5440 WADE PARK BLVD, SUITE 102 WWW.BGEINC.COM NC LICENSE #C-4397 ©2023	DESIGNED BY:				
	DRAWN BY:				
	REVIEWED BY:		DF		
			DF/JWM	10/02/2023	PER TOWN OF ROLESVILLE COMMENT
				08/01/2023	PER TOWN OF ROLESVILLE COMMENT
		REV	06/01/2023	INITIAL SUBMITTAL

PARKER RIDGE
82 SCHOOL STREET
ROLESVILLE / NORTH CAROLINA / 27571

CARVED STREET CT PLAN
AND PROFILE

GRANITE KNOLL CT PLAN
AND PROFILE (2 OF 2)

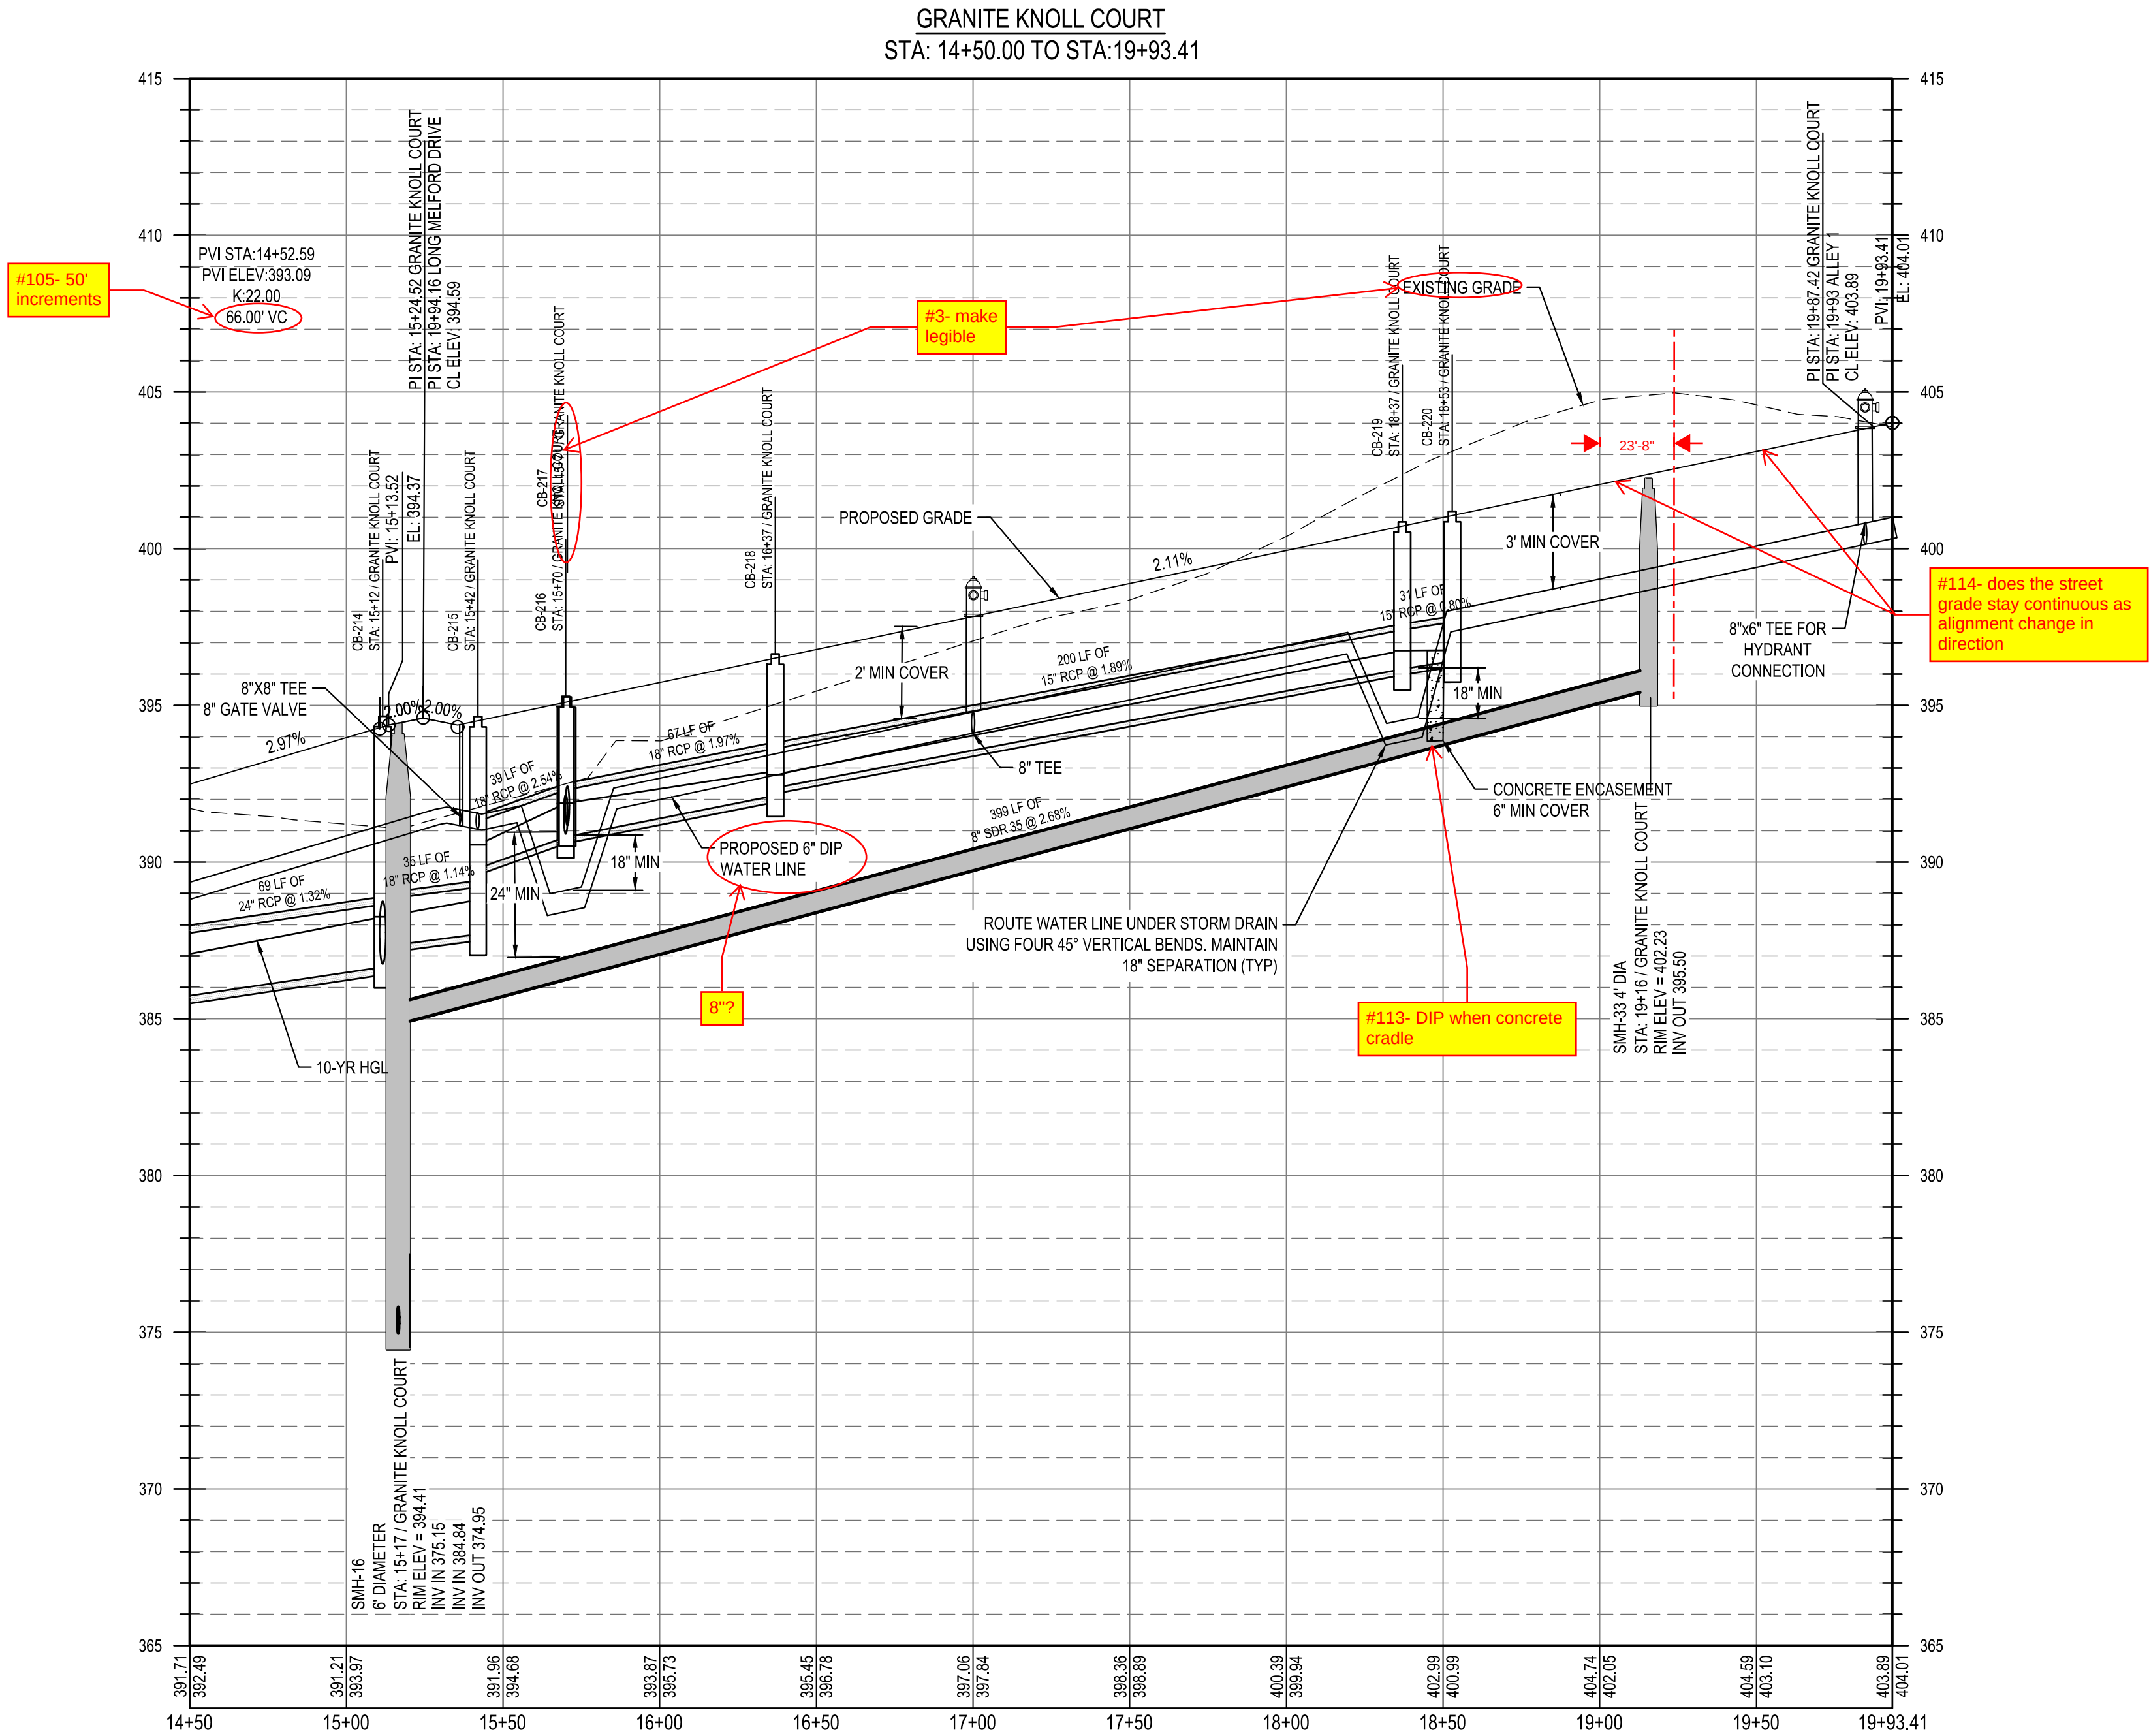
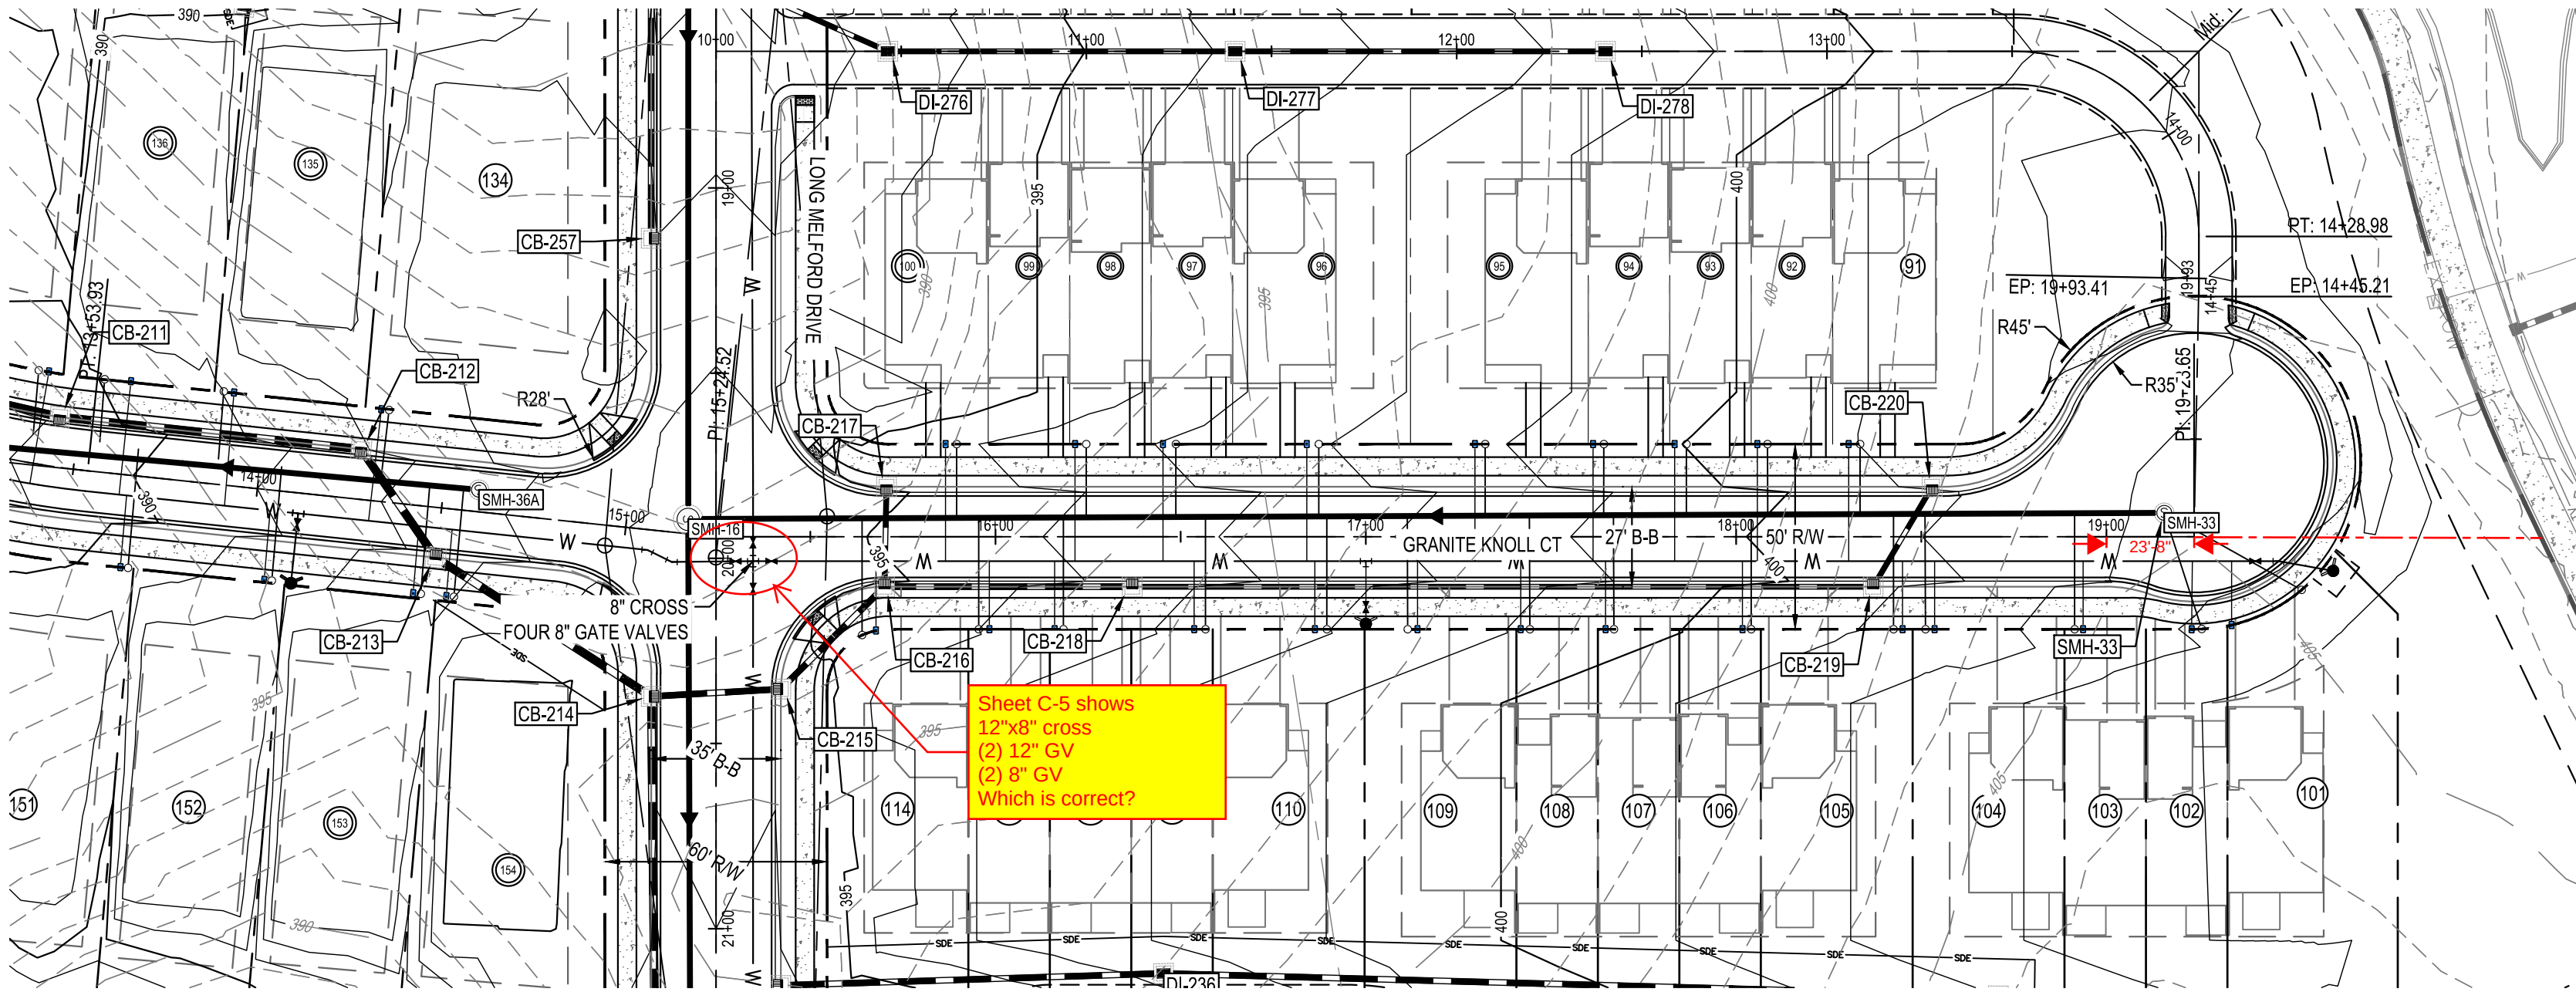
#23- There are several instances where water line, tees/crosses, and valve sizes differ between Utility plan sheets and Plan and Profile sheets. Please make the necessary adjustments to ensure that water lines, connections, and valves correct sizes remain consistent throughout all sheets.
